ENTERGY OPERATIONS, INC.

ARKANSAS NUCLEAR ONE, UNIT ONE

Subject: Arkansas Nuclear One - Unit 1
Docket No. 50-313
License No. DPR-51
Proposed Technical Specification Change Revising The Pressurizer Code Safety
As-Found Setpoint Tolerance

DESCRIPTION OF PROPOSED CHANGES

ARKANSAS POWER & LIGHT CO. ARKANSAS NUCLEAR ONE-UNIT 1	PEAK THERMAL POWER VS DOPPLER COEFFICIENT FOR A STARTUP ACCIDENT, USING A 3.0% $\Delta k/k$ ROD GROUP AT $2.15 \times 10^{-4} (\Delta k/k)/s$ FROM 10^{-9} RATED POWER	FIG. NO. 14-5
---	--	------------------

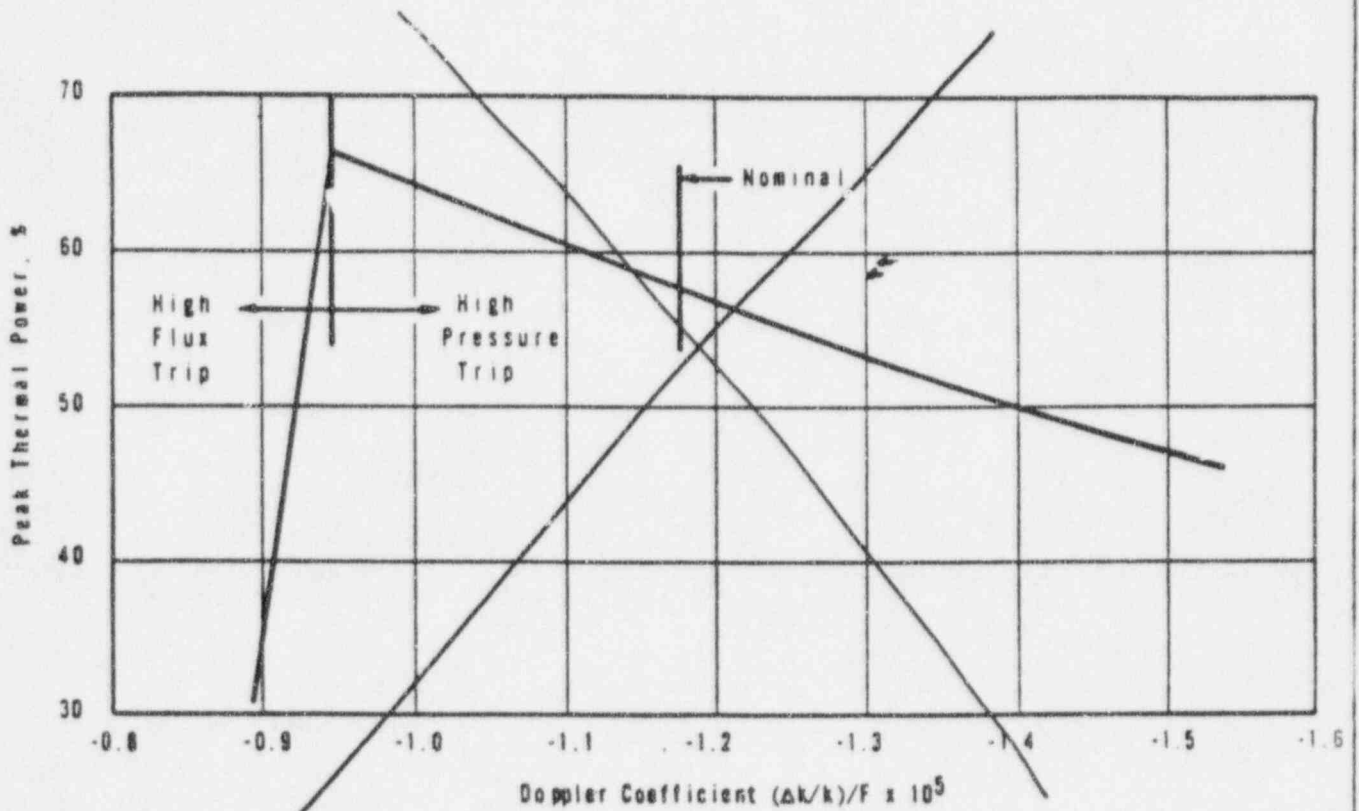
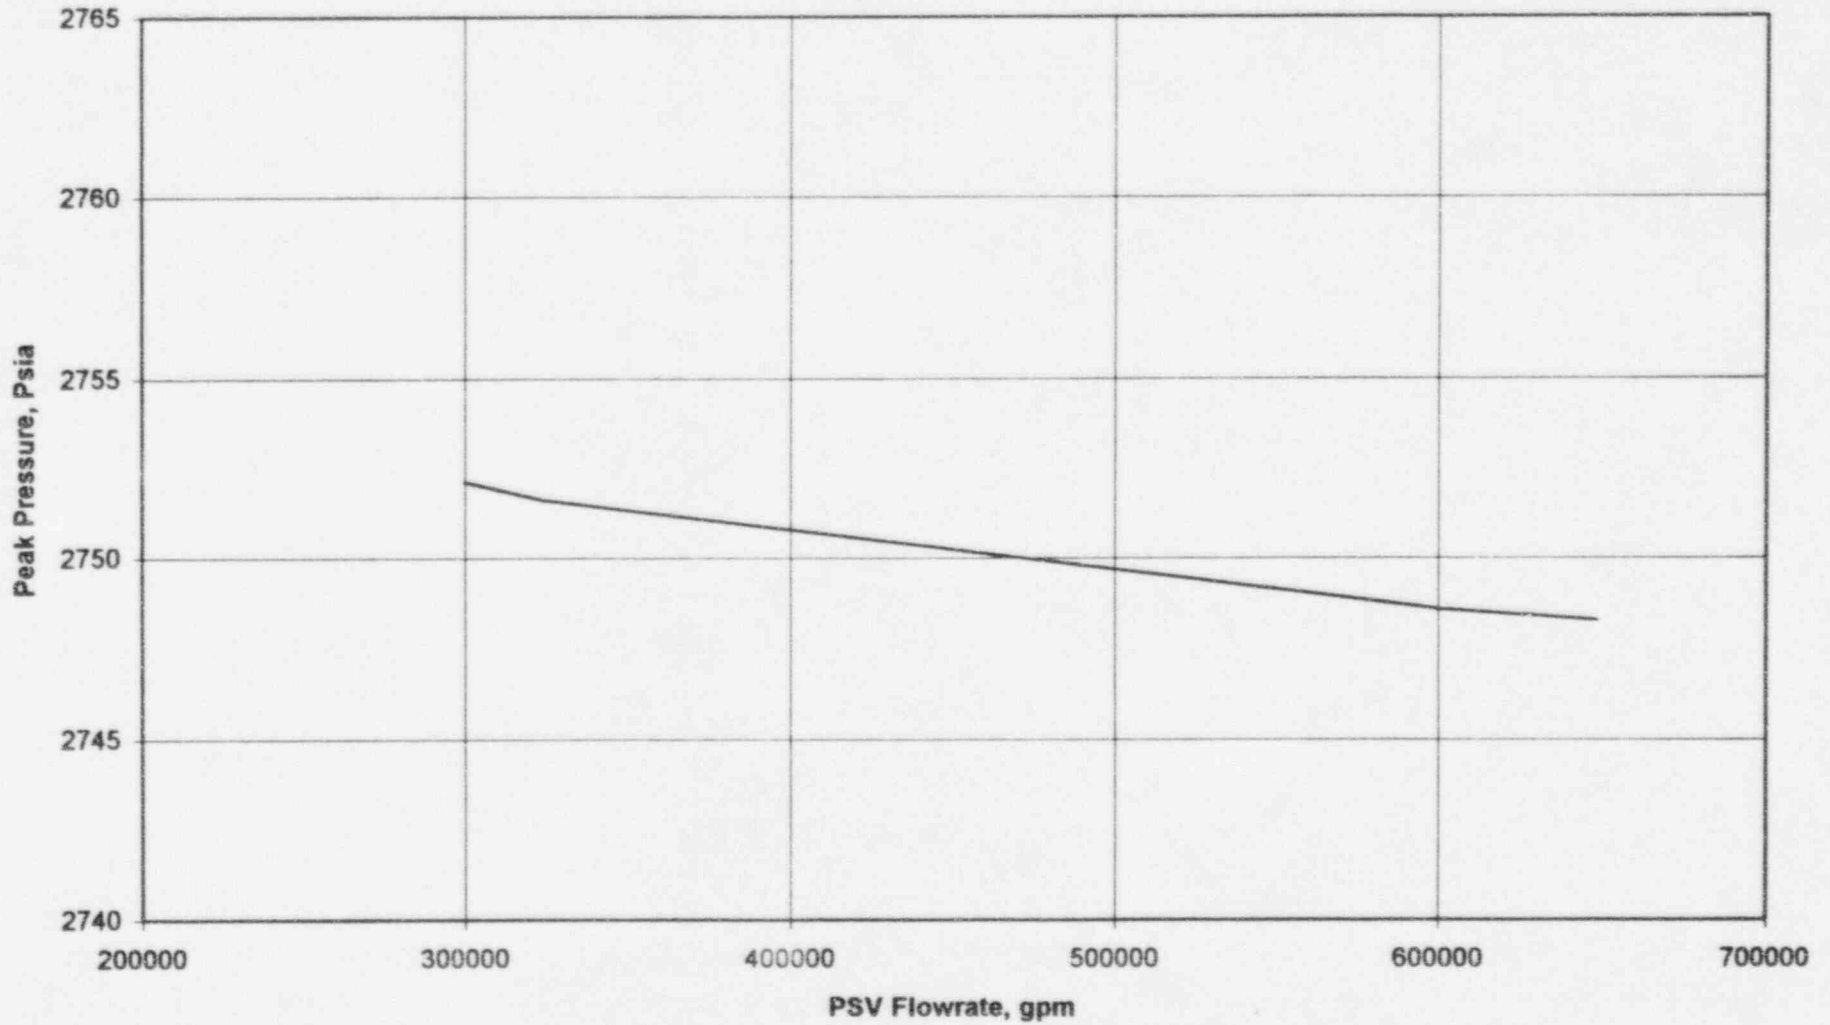
Figure 14-5 shows the effect of varying the pressurizer safety valve flow rate from a single PSV flow rate of 300,000 lbm/hr to 2 PSVs with a flow rate of 324,000 lbm/hr/valve.

FIG. NO.
 14-6

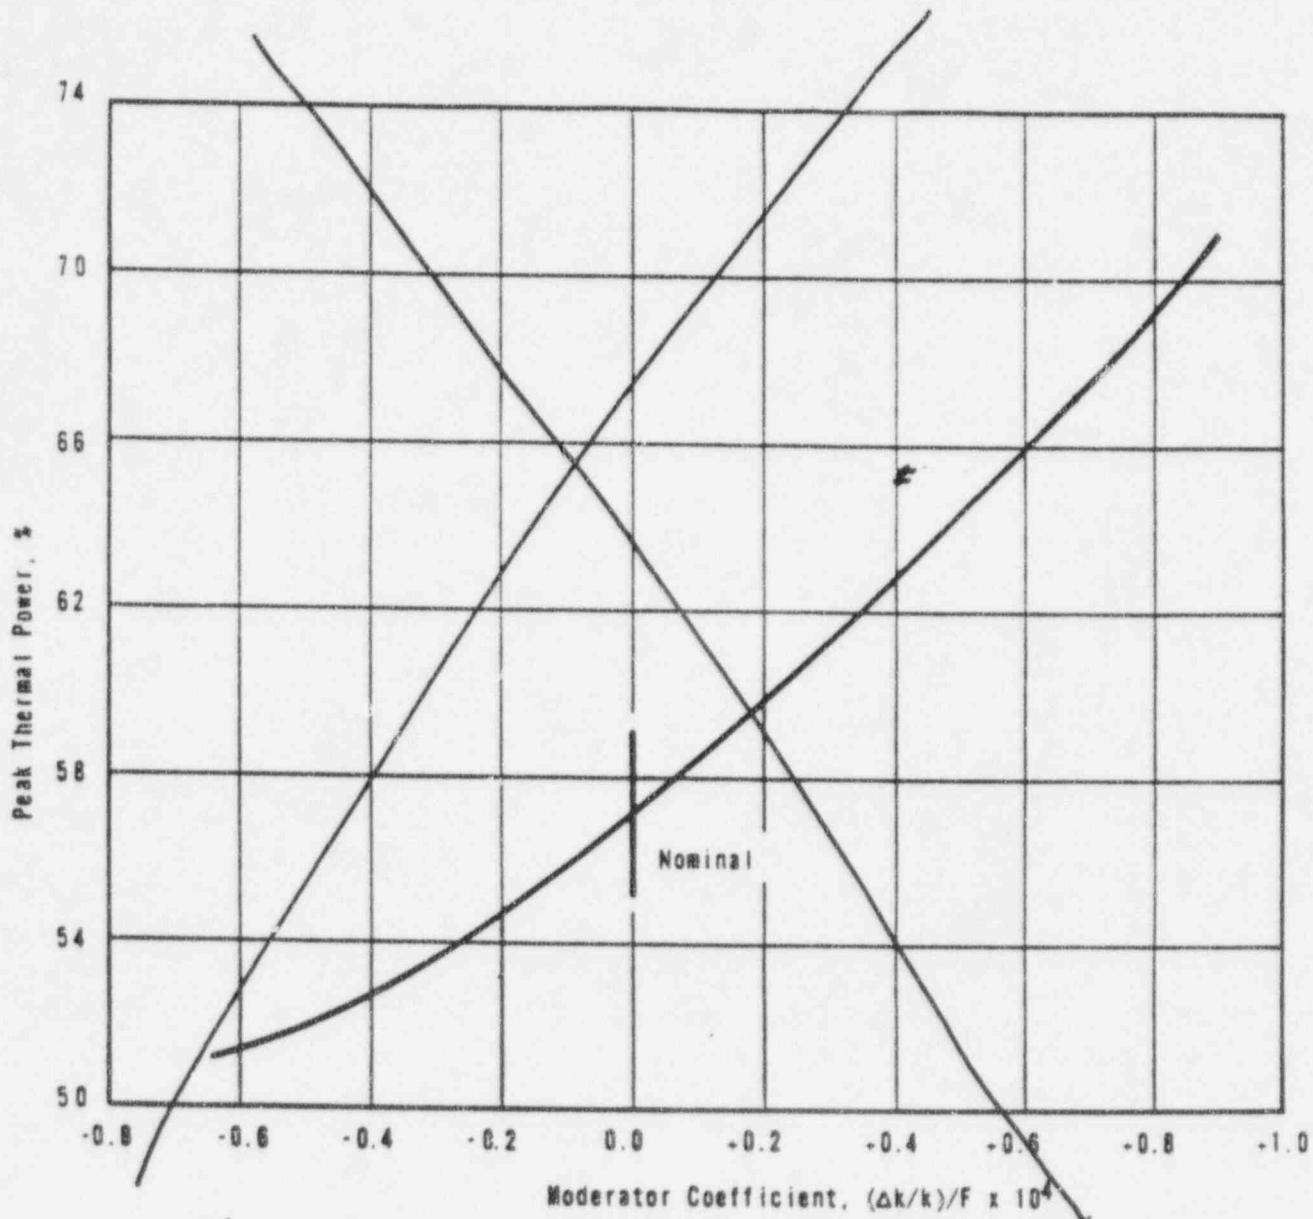
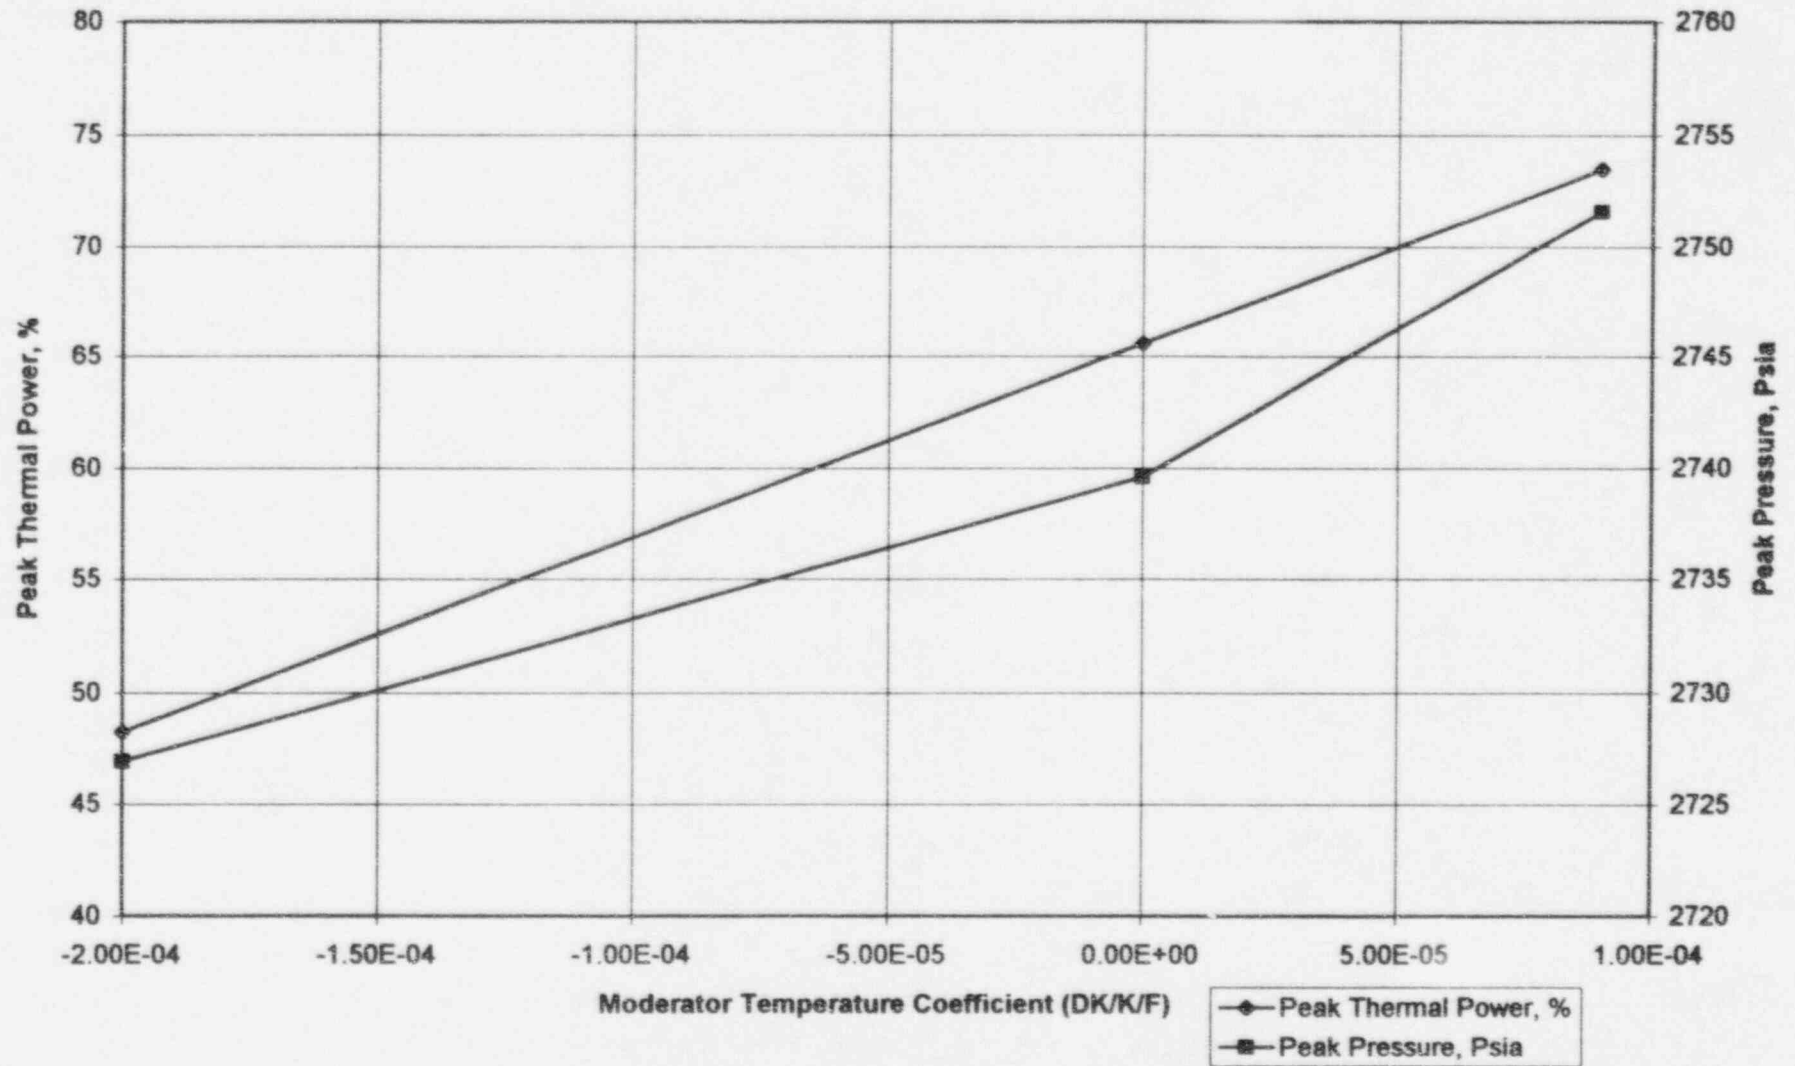
Figure 14-6 shows the peak thermal power ^{and peak pressure} variation as a function of ~~a range of reactivity addition rates that result in worst case peak pressure and thermal power.~~ ^{a range of reactivity addition rates that result in worst case peak pressure and thermal power.}

ARKANSAS POWER & LIGHT CO. ARKANSAS NUCLEAR ONE-UNIT 1	PEAK THERMAL POWER VS DOPPLER COEFFICIENT FOR A STARTUP ACCIDENT USING ALL RODS AT 9.27×10^{-4} $(\Delta k/k)/\beta$ FROM 10^{-9} RATED POWER	FIG. NO. 14-7
---	--	------------------

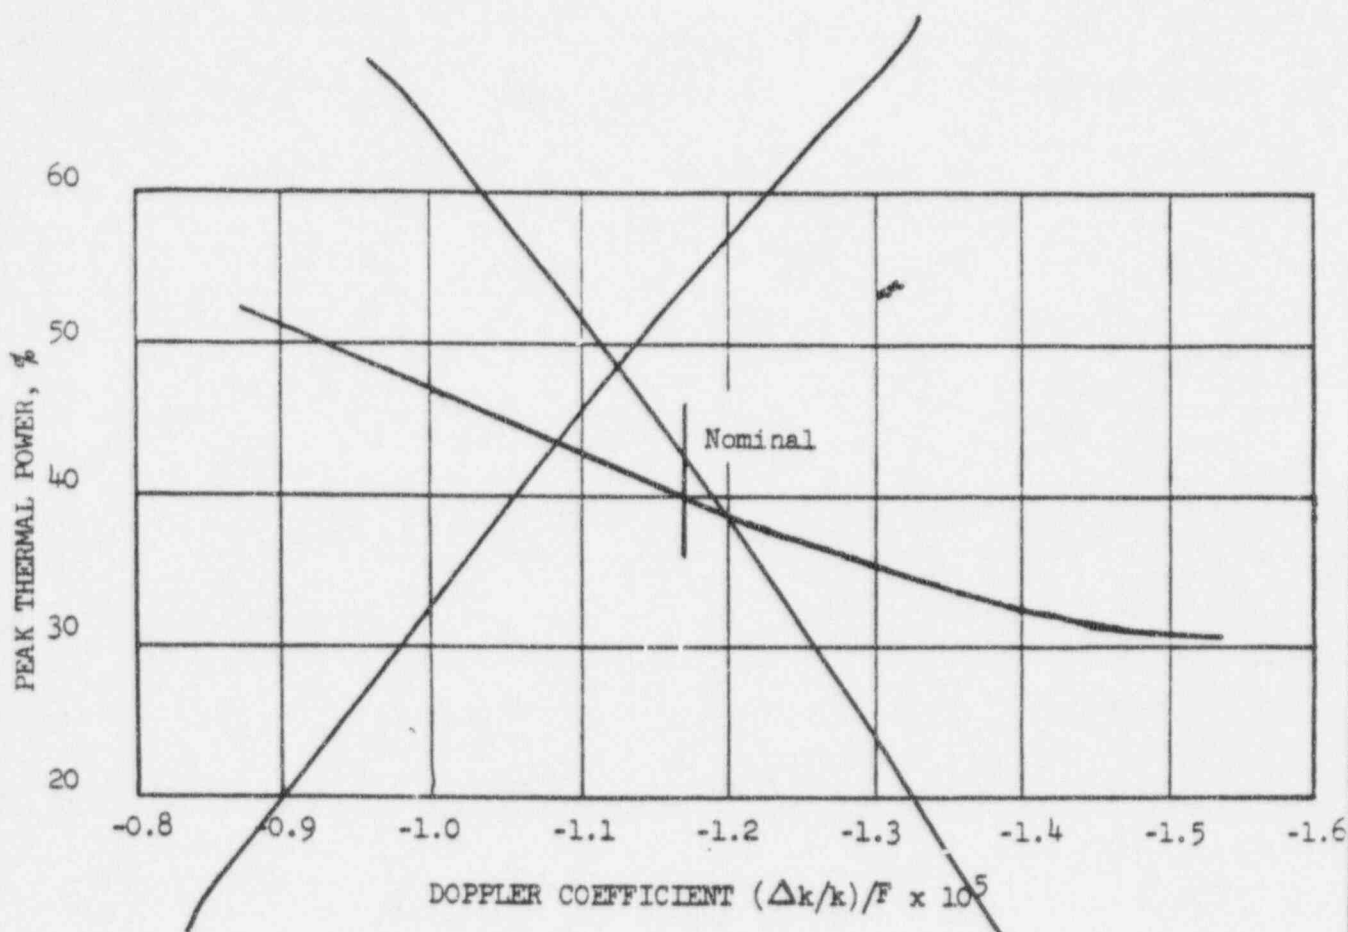
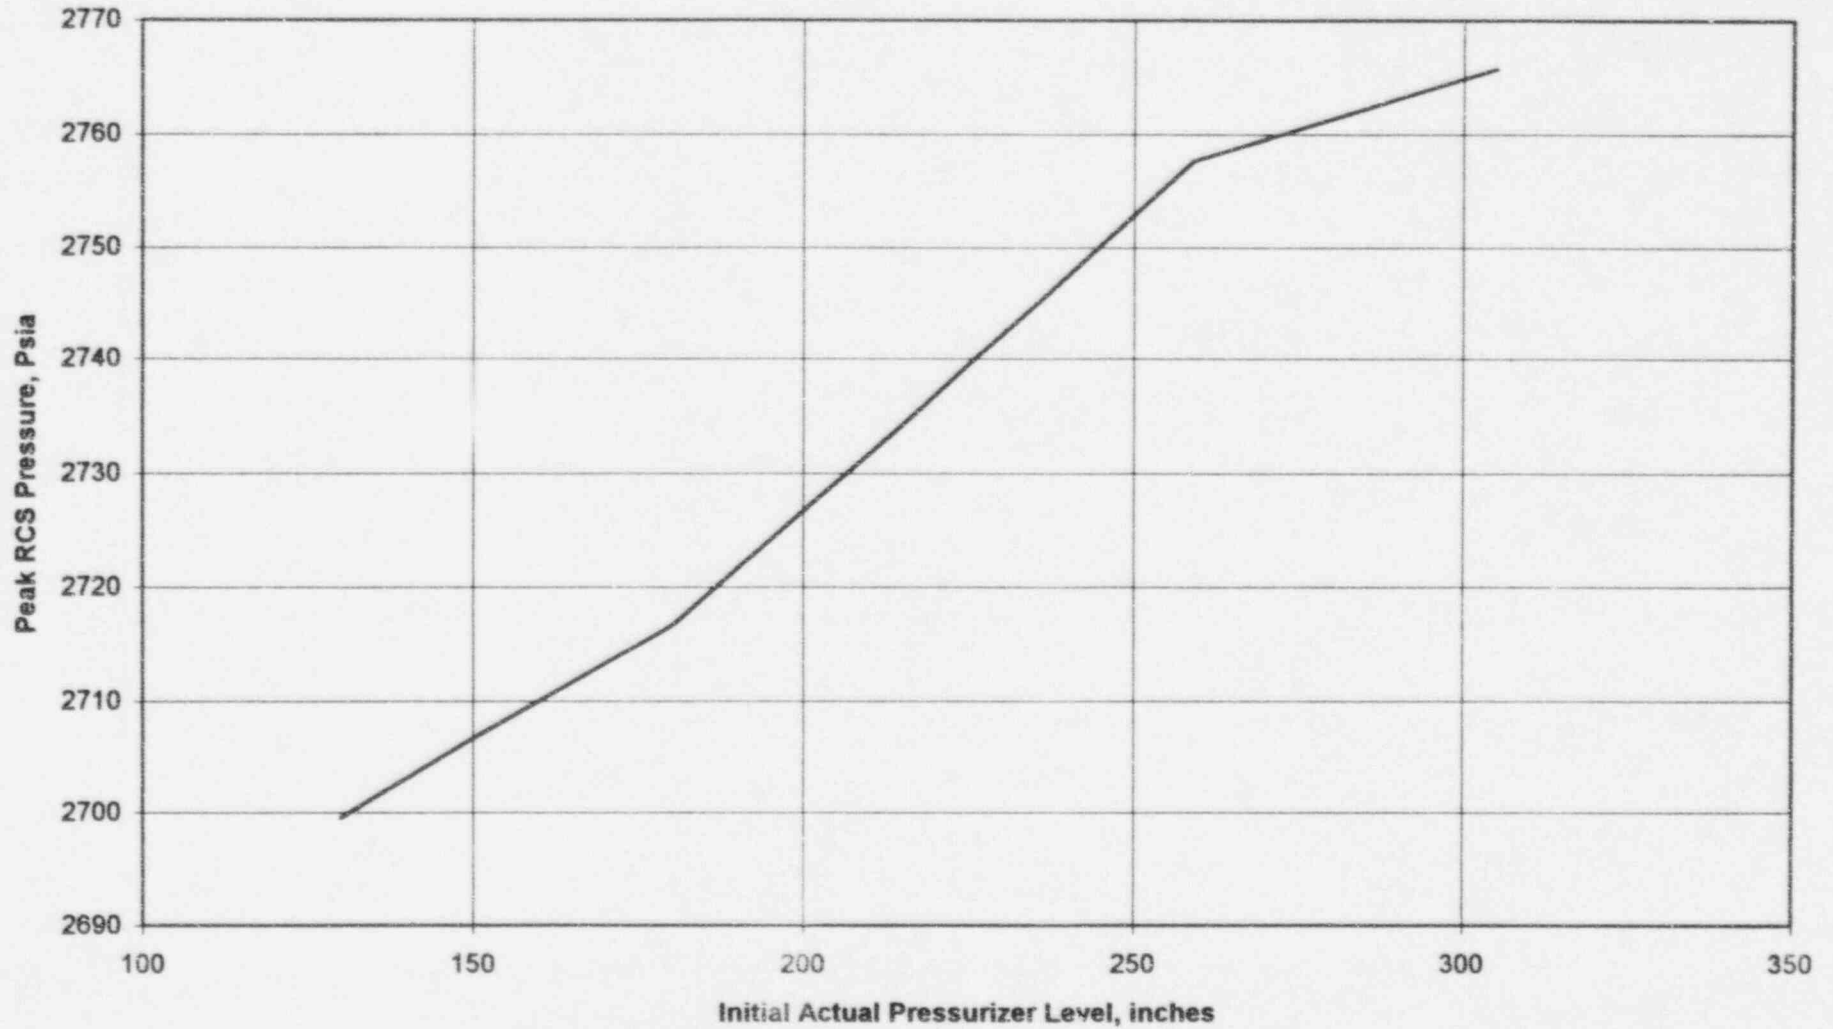
The peak RCS pressure was found to be dependent on the initial pressurizer level. Higher initial pressurizer levels result in less volume to accommodate the expansion of the RCS volume due to the heat input caused during the startup event. Figure 14-7 shows the resultant peak pressure corresponding to the reactivity addition rate that results in peak pressure.
